Addendum #2
Avon-Washington Township Public Library
Addition and Furniture Project

Date: July 30, 2025
Project: Avon-Washington Township Public Library – Addition and Furniture Project
Project #: 24029
Pages: 16
Bid Dates: **THURSDAY, August 14, 2025 at 2:00 pm (prevailing local time)**

1 ROOF PLAN

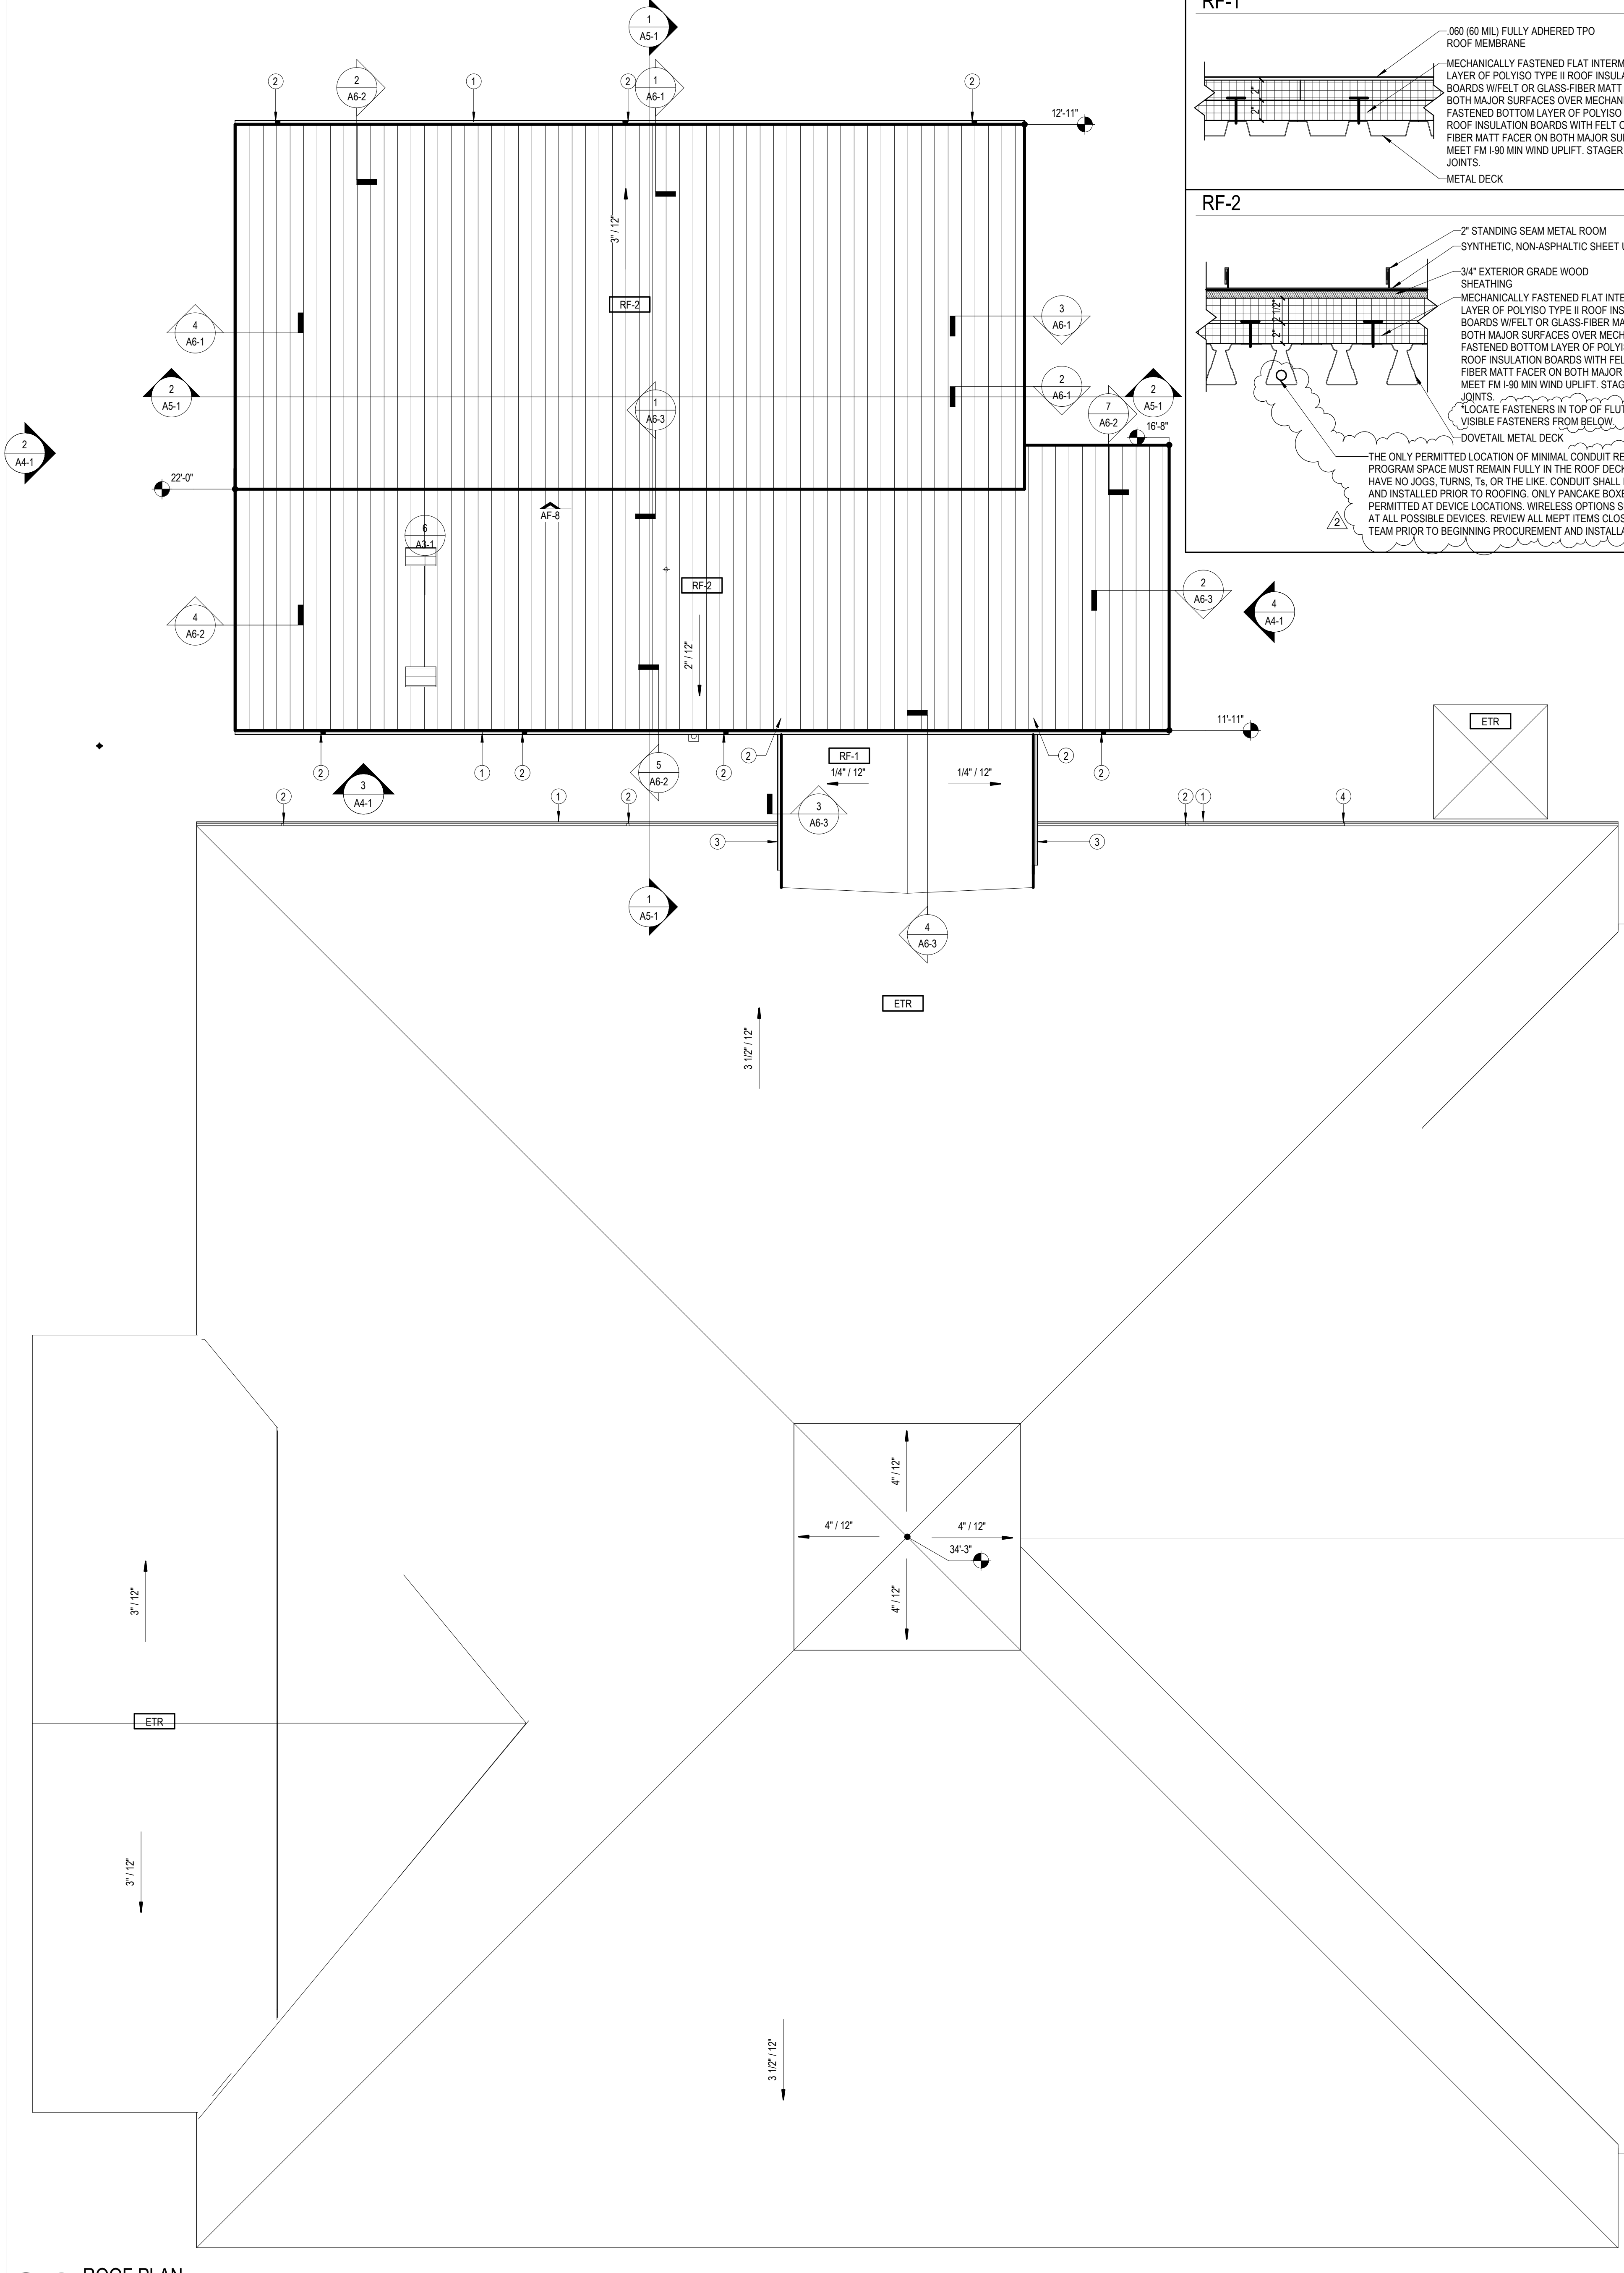
1. REVISE RF-2 detail as shown in the attached reissued sheet.

ROOF SCHEDULE	
ETR	EXISTING ROOF TO REMAIN
RF-1	FULLY ADHERED TPO ROOF OVER MIN. R-20 RIGID INSULATION. REFER TO SPECIFICATIONS
RF-2	STANDING SEAM METAL ROOF SYSTEM OVER MEMBRANE, 3/4" PLYWOOD, 4.5" INSULATION, 3.5" DOVETAIL ACOUSTIC STEEL DECK. REFER TO SPECIFICATIONS
RF-3	FLAT LOCK METAL ROOF SYSTEM OVER MEMBRANE, 3/4" PLYWOOD, 2" INSULATION, STEEL STRUCTURE. REFER TO SPECIFICATIONS

Sheet A10-1 Interior Elevations & Casework Details

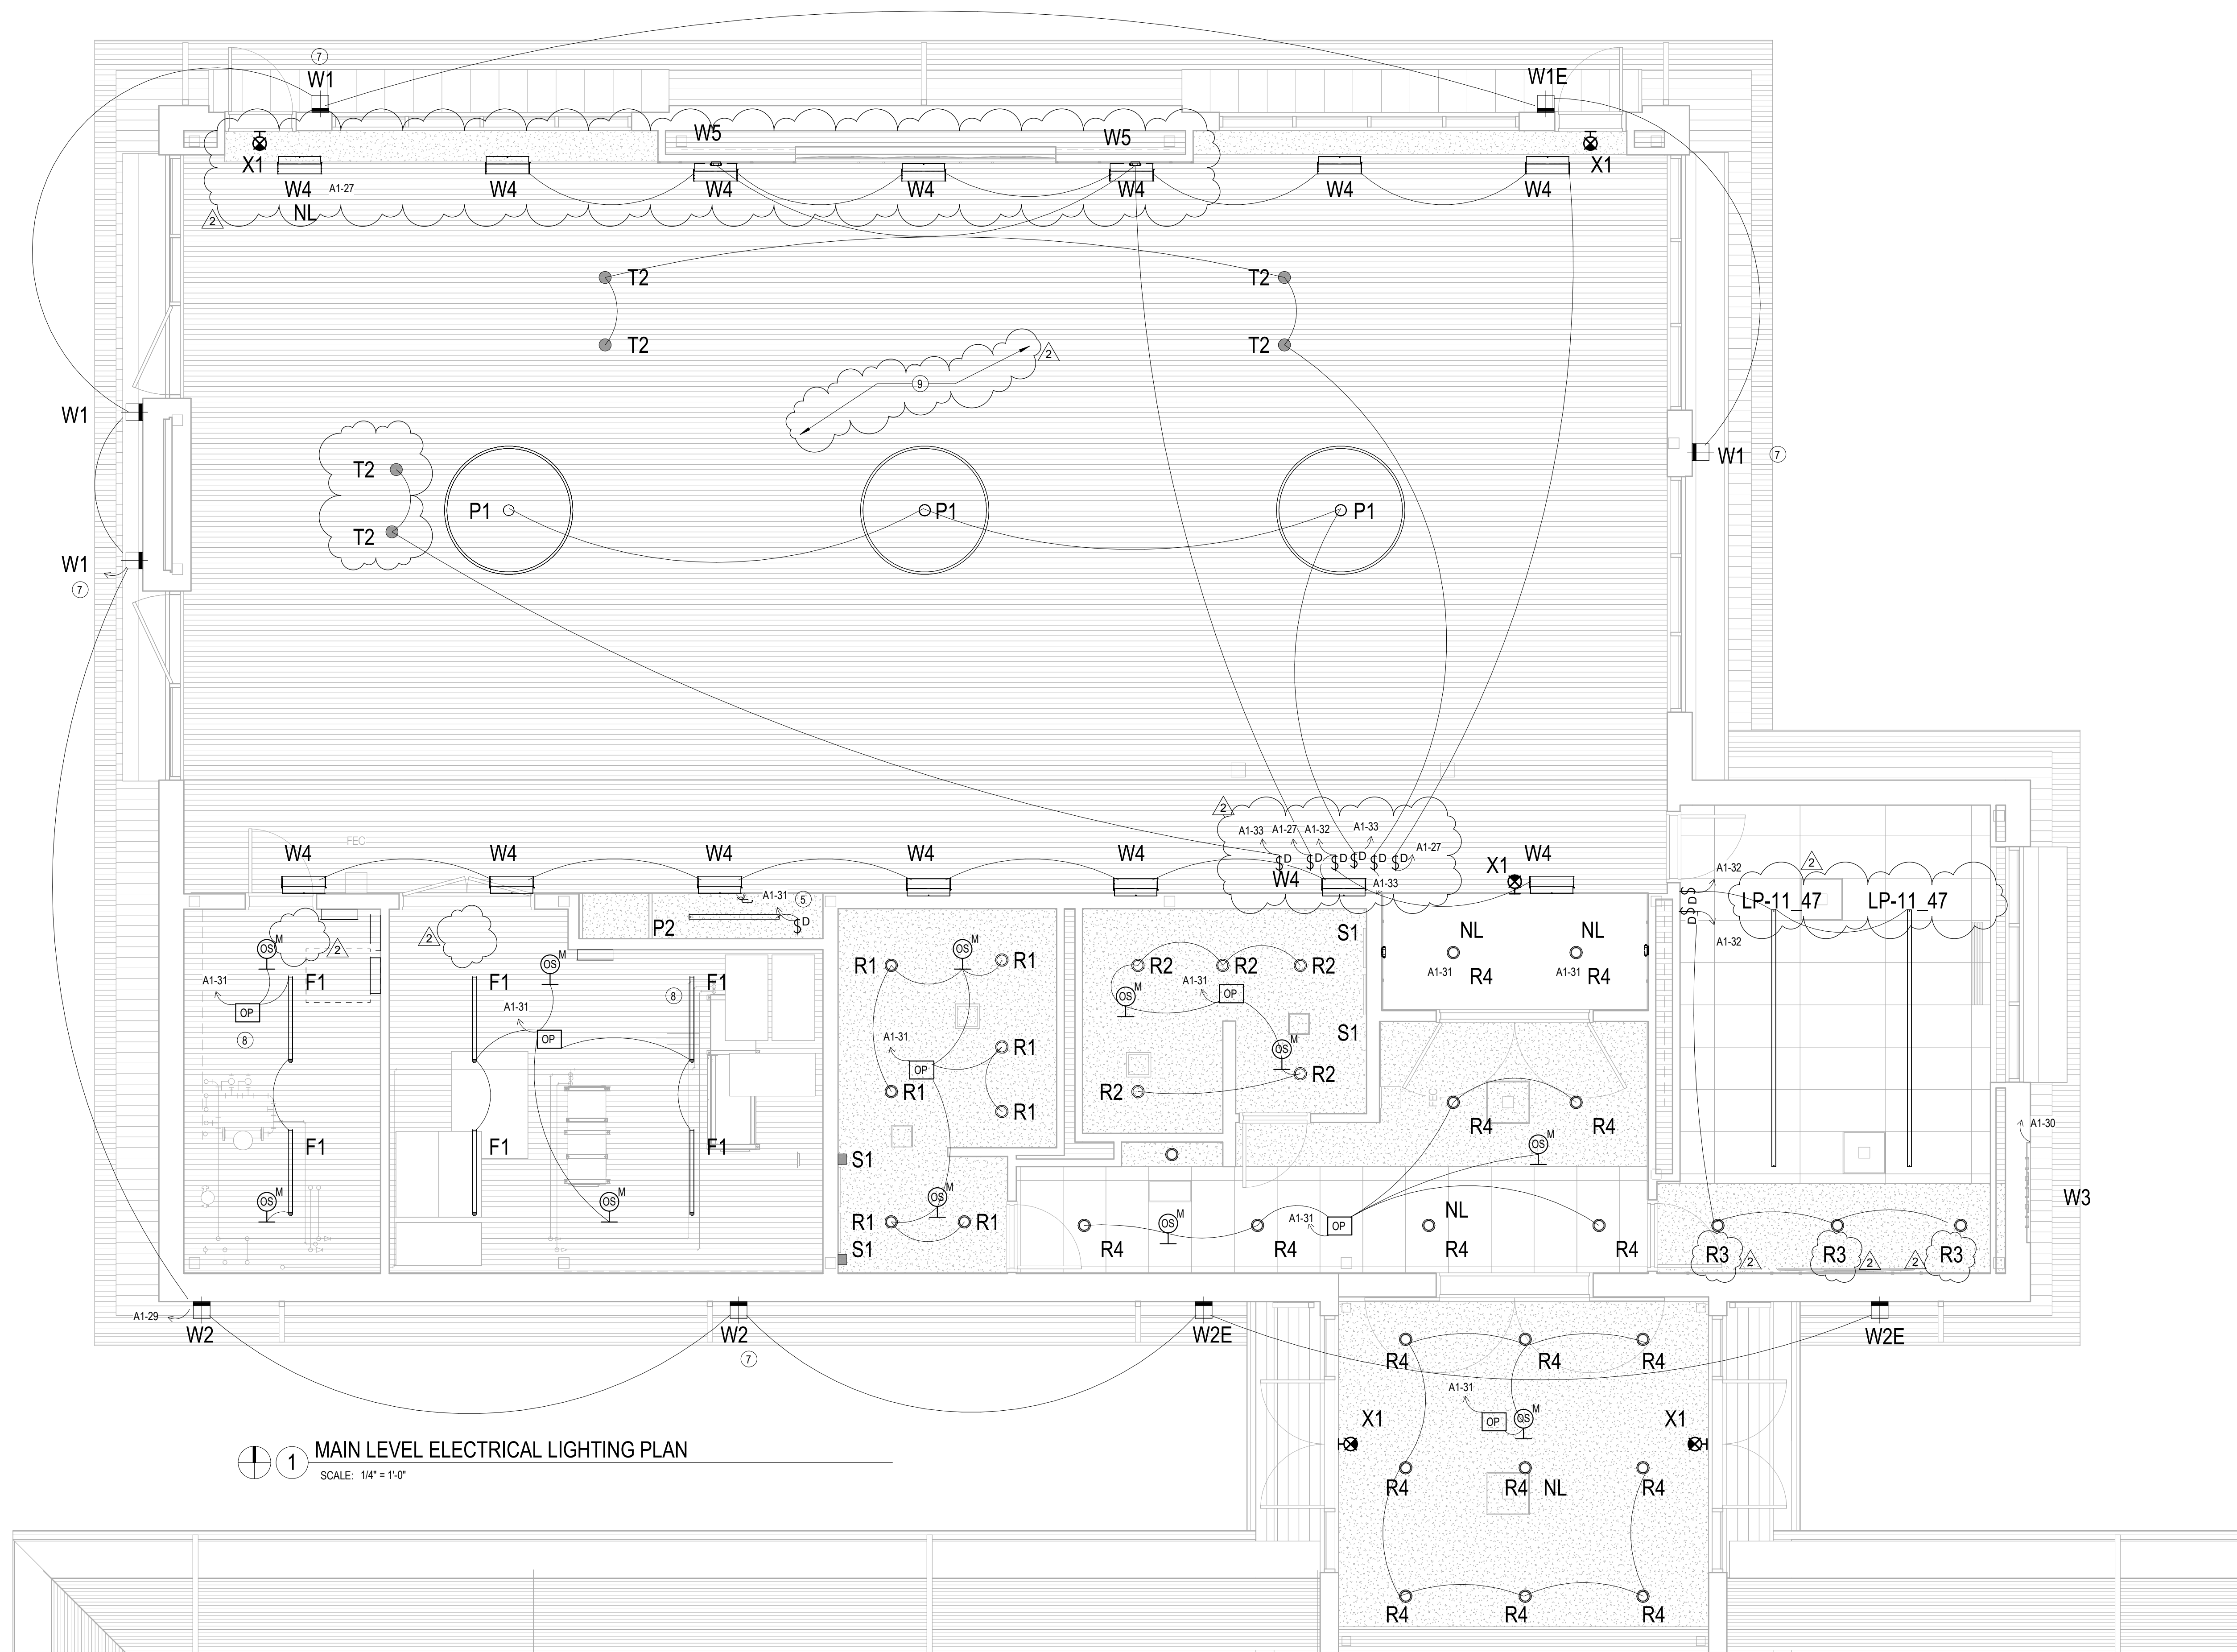
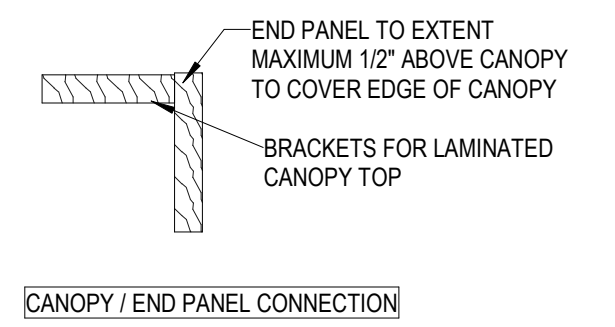
1. ADD general note regarding alternates as indicated on the attached reissued sheet.
2. CLARIFY that metal library shelving is OFOI.

REFERENCES TO ALTERNATES AND BASE BID ARE INTENDED TO BE INTERPRETED IN RELATION TO ALL DRAWINGS AND SPECIFICATIONS FOR COMPLETE UNDERSTANDING OF SCOPE. BIDDERS SHALL REVIEW ENTIRETY OF CONTRACT DOCUMENTS IN REGARD TO ALTERNATES.

NOTE: METAL LIBRARY SHELVING SHALL BE OF 100% STEEL
